PJM Interconnection, L.L.C.  
Docket No. ER20-1044-000

Reference: First Revised Service Agreement No. 5227

Re: *PJM Interconnection, L.L.C. Docket No. ER20-1044-000*  
*First Revised Service Agreement No. 5227; Queue No. AE1-154*

**CUSTOMER FACILITY LOCATION/SITE PLAN**

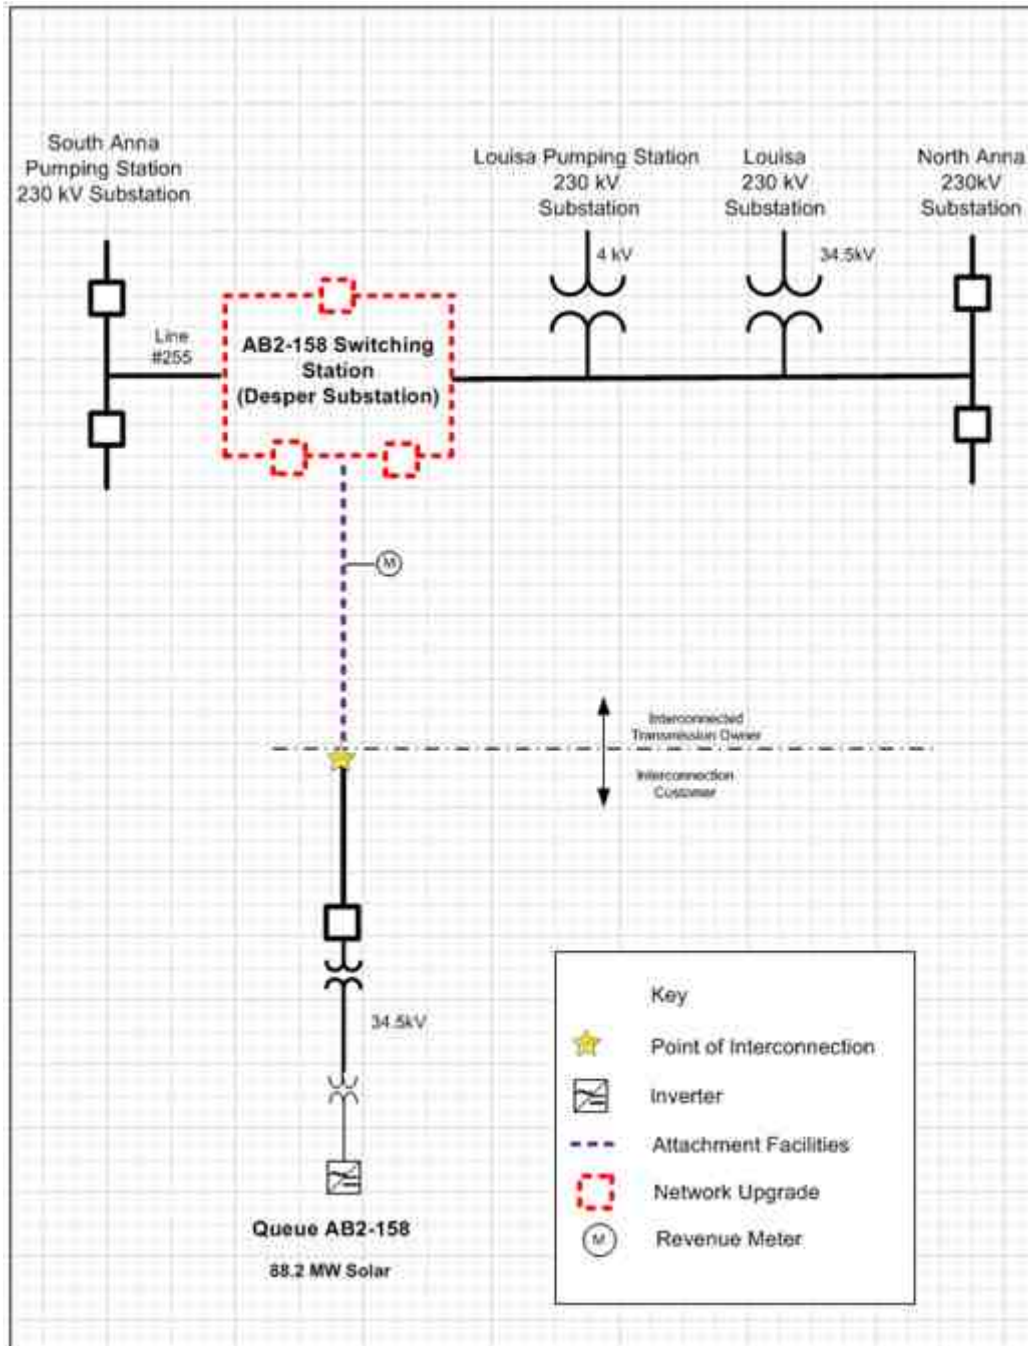
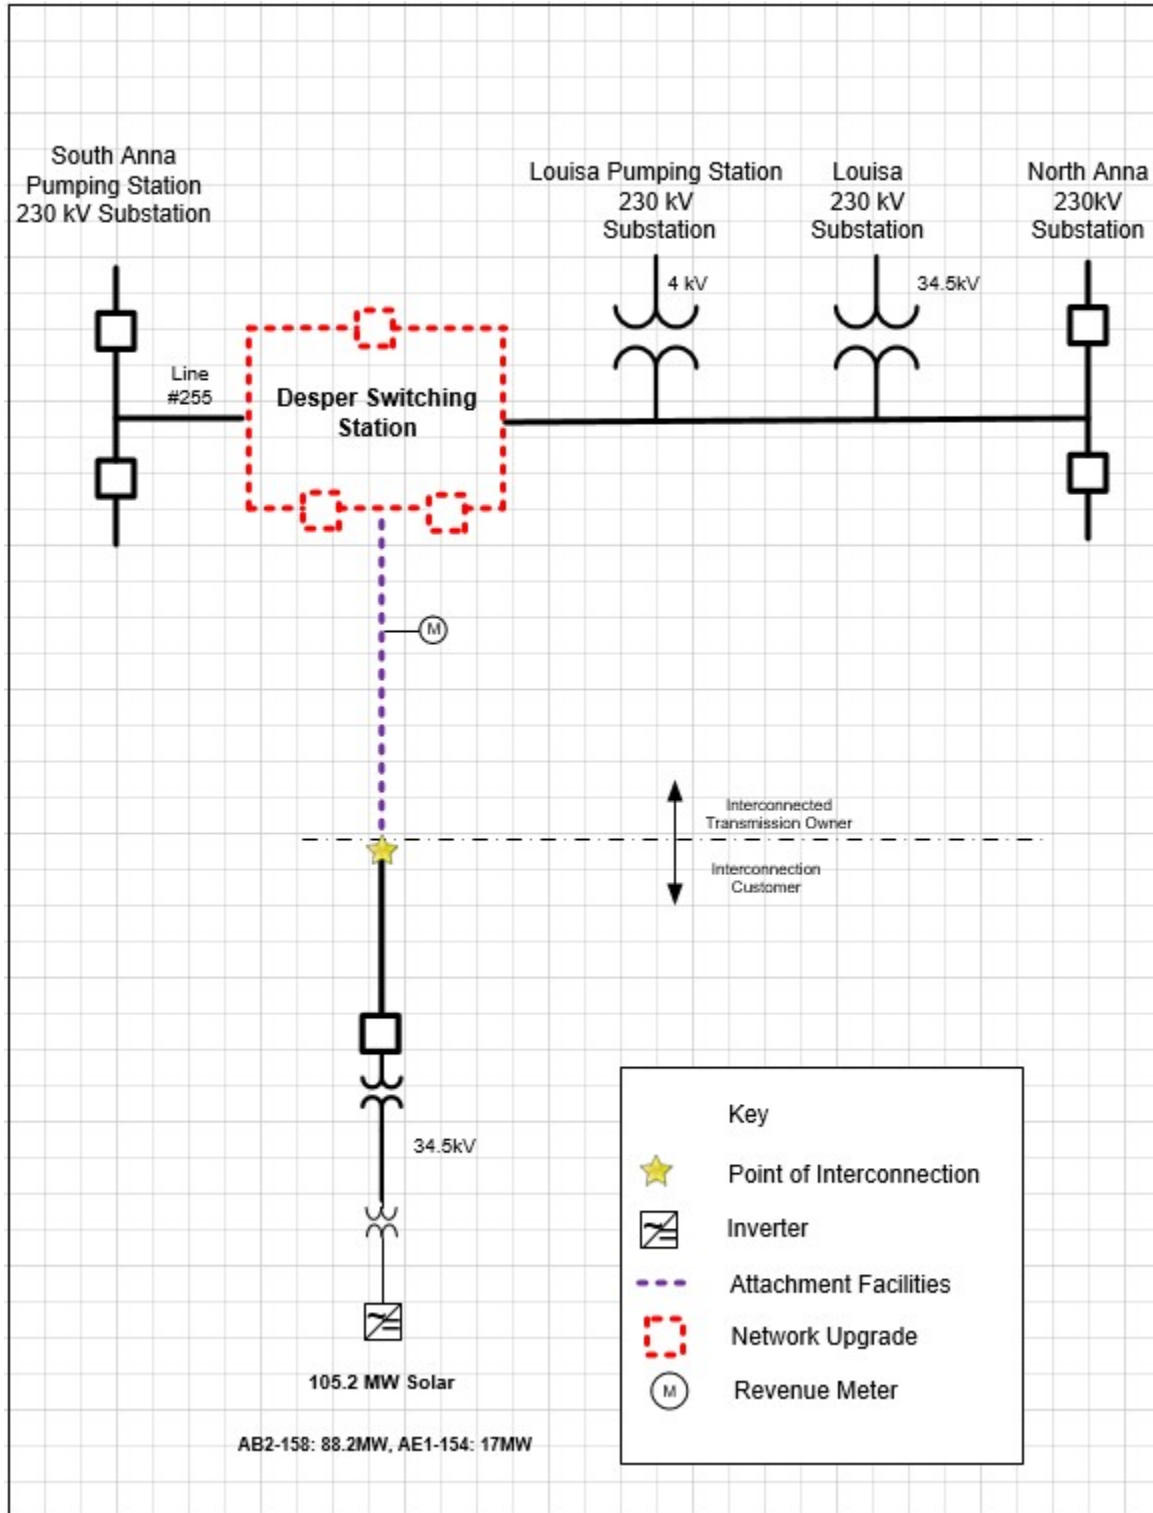
Ninth, VEPCO ISA, Schedules A and B reflect updated images of the Customer Facility Location/Site Plan and the Single-Line Diagram, respectively.
